## Architect's Supplemental Instructions

**PROJECT:** *(name and address)*  
17-13 OSU College of Med. at Hastings  
Tahlequah, OK

**ASI INFORMATION:**  
ASI Number: Bid Pack 03 - ASI 01  
Date: 4/22/19

**Bid Package 03- ASI 01 – OSU College of Osteopathic Medicine At The Cherokee Nation**

SHEET NUMBER:  
**S0.03**

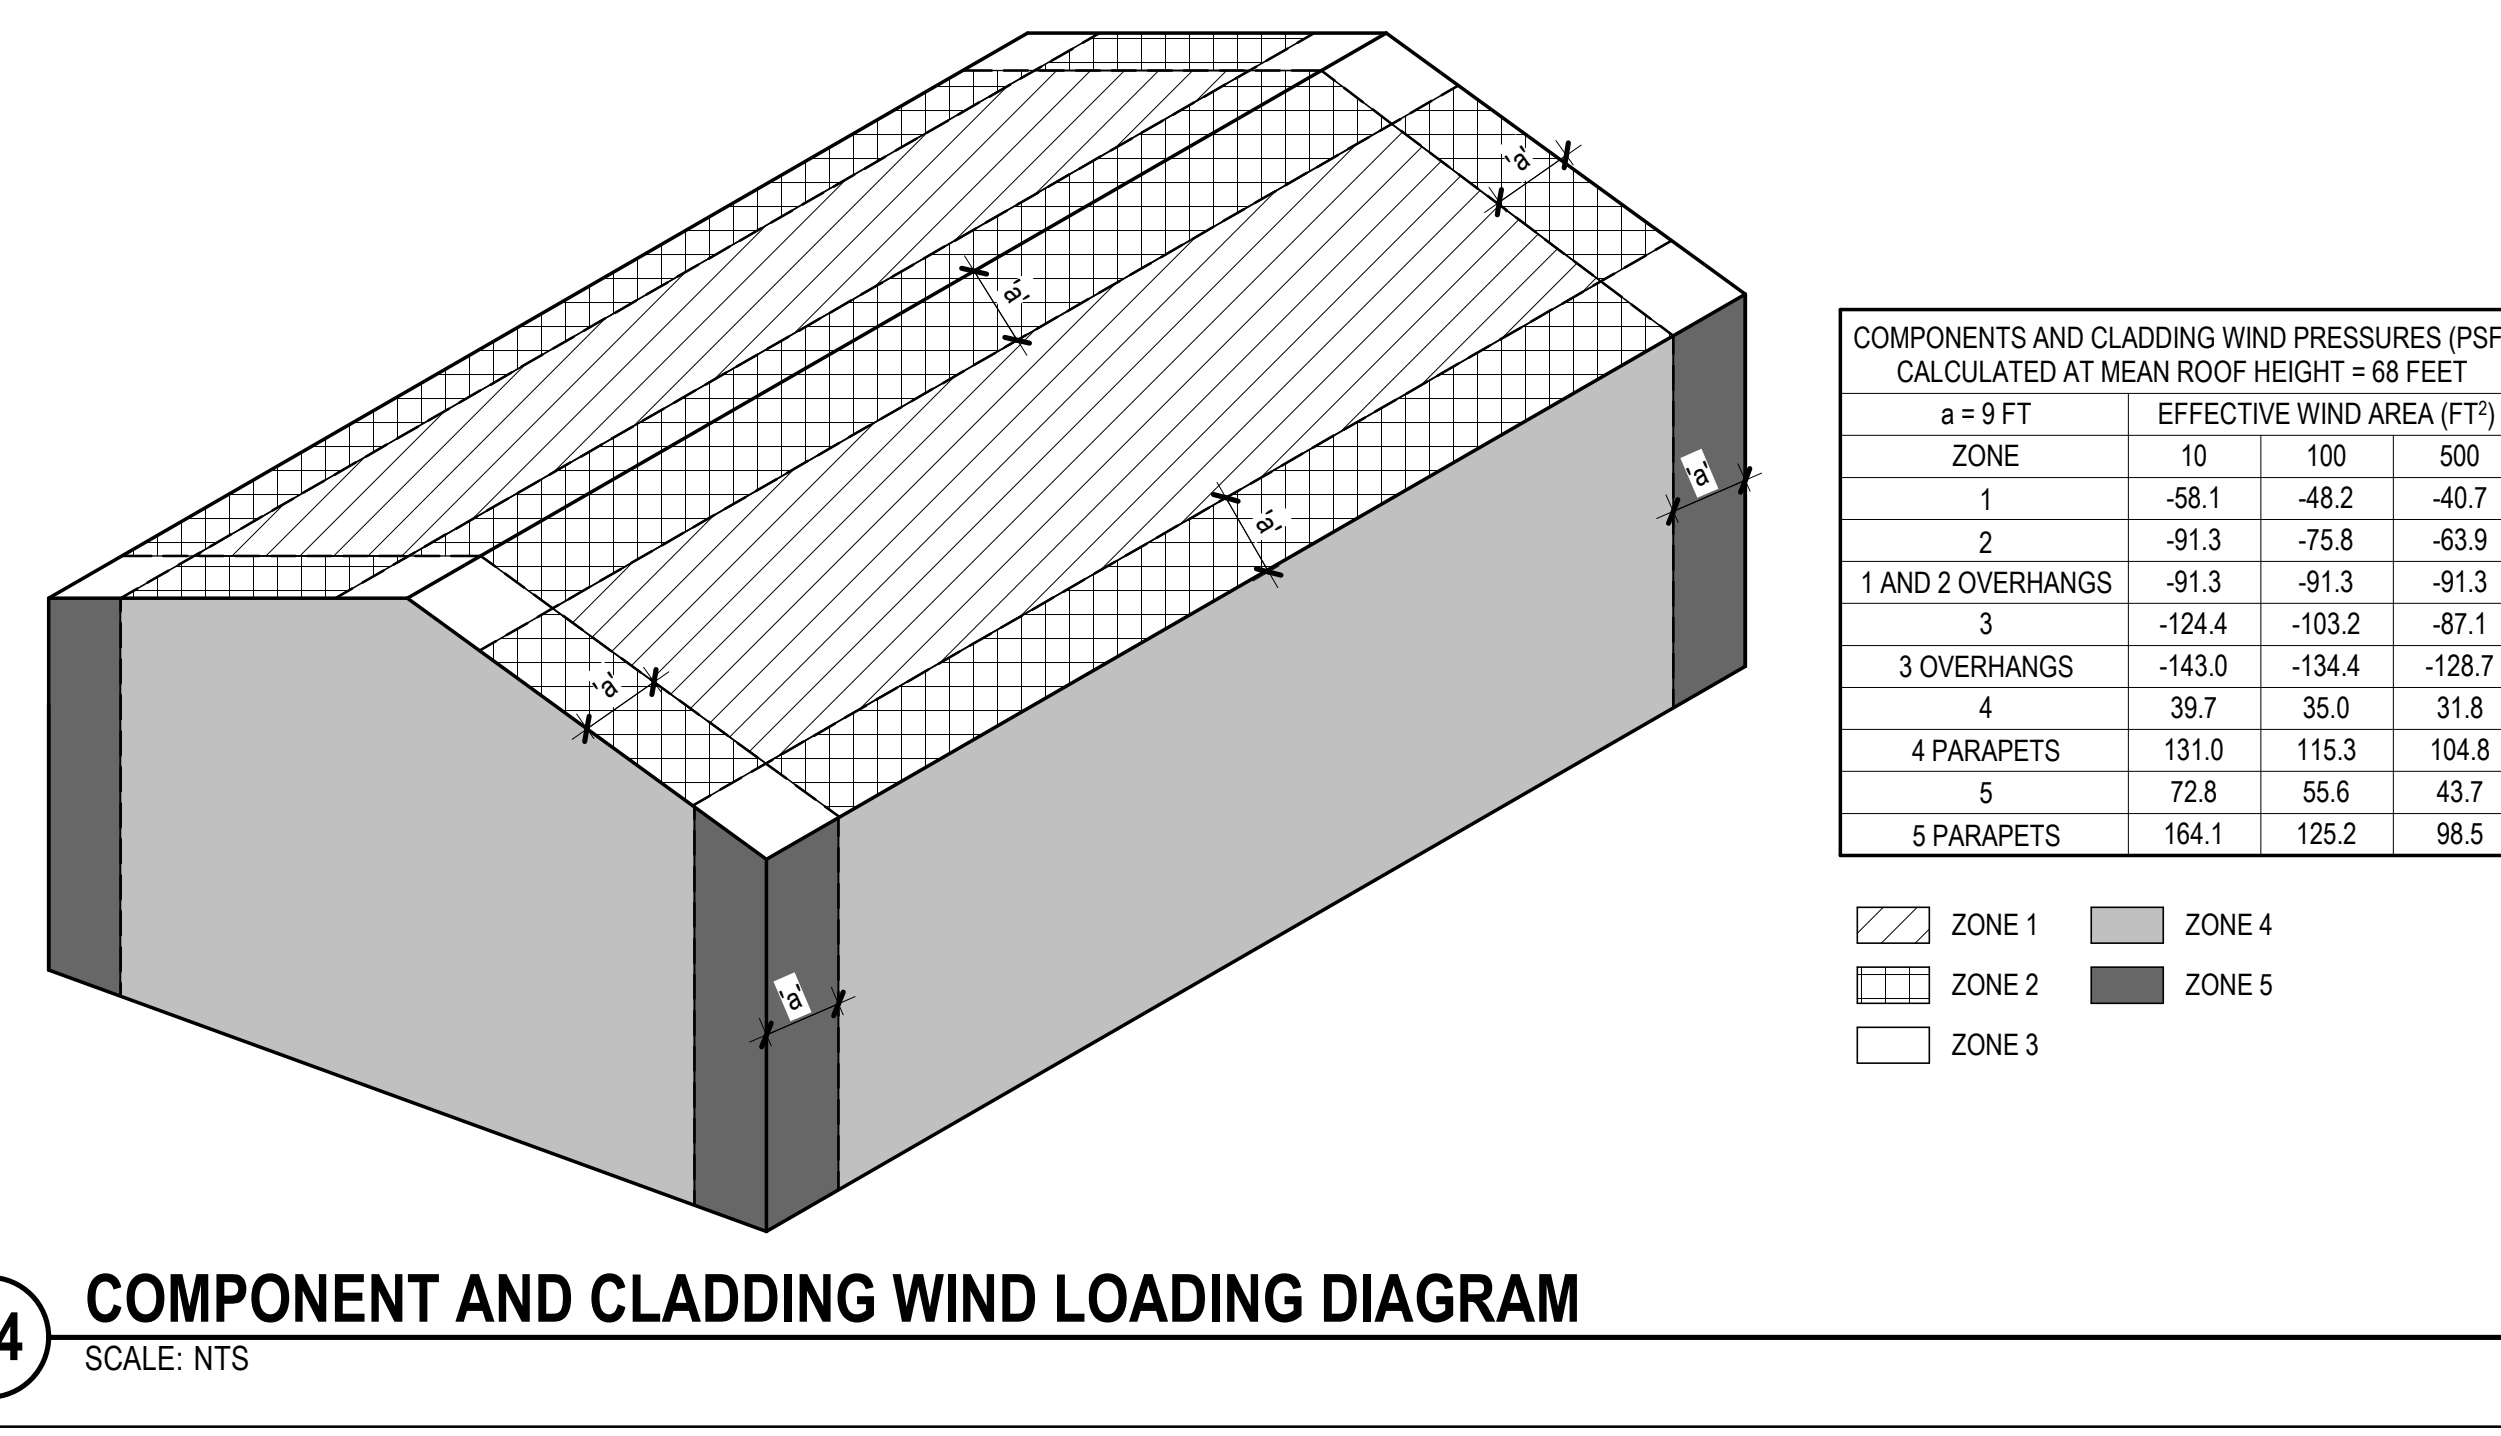
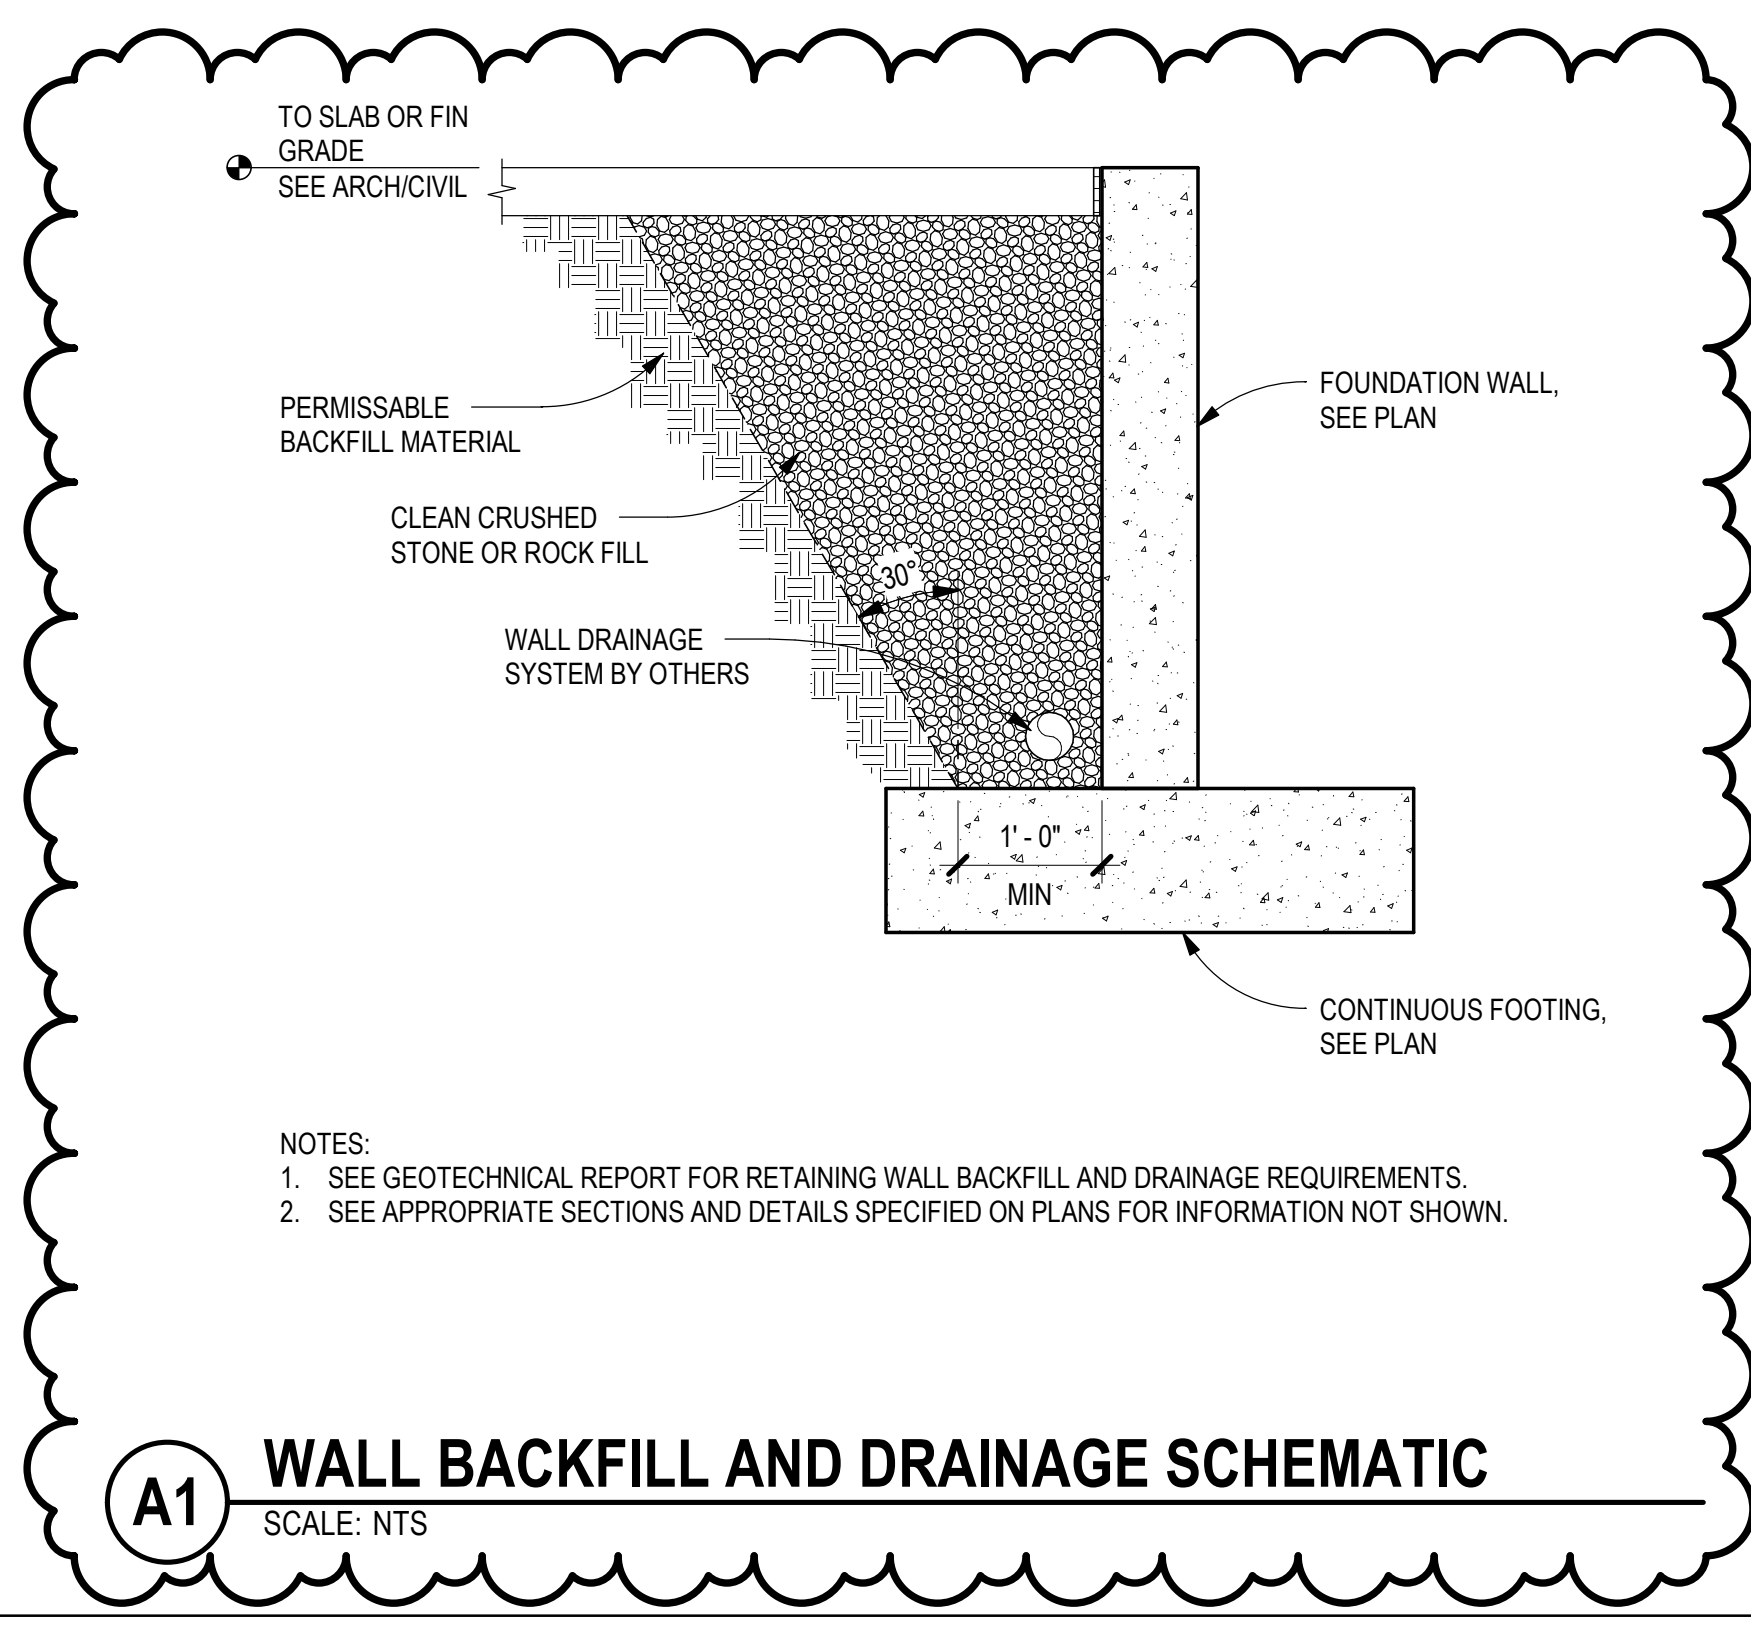
<b><u>Sheet</u></b>	<b><u>Description</u></b>
S0.02	Revised information based on the revised geotechnical report dated April 4, 2019.
S0.02	Revised deferred submittals content.
S0.03	Wall backfill and drainage schematic added (A1/S0.03).
S1.02	Site retaining wall added to plan, near Grid 4.
S1.02	Spread footing size at Grid J-2.5 revised.
S1.02	Spread footing size at Grid H-1, H-2, and H-3 revised.
S1.02	Spread footing size at Grid G-1, G-2, G-3, and G-4 revised.
S1.02	Spread footing size at Grid F-1, F-2, F-3, and F-4 revised.
S1.02	Spread footing size at Grid E-1, E-2, E-3, and E-4 revised.
S1.02	Location of continuous footing parallel to Grid E revised.
S1.02	Under slab French drain system information clarified, moved from general sheet note 9, to sheet keynote 8.
S1.02	Under slab French drain system schematically shown on plan.
S1.02	Location of continuous footing parallel to Grid E revised.
S1.02	Sheet keynote 9, for site retaining wall, added.
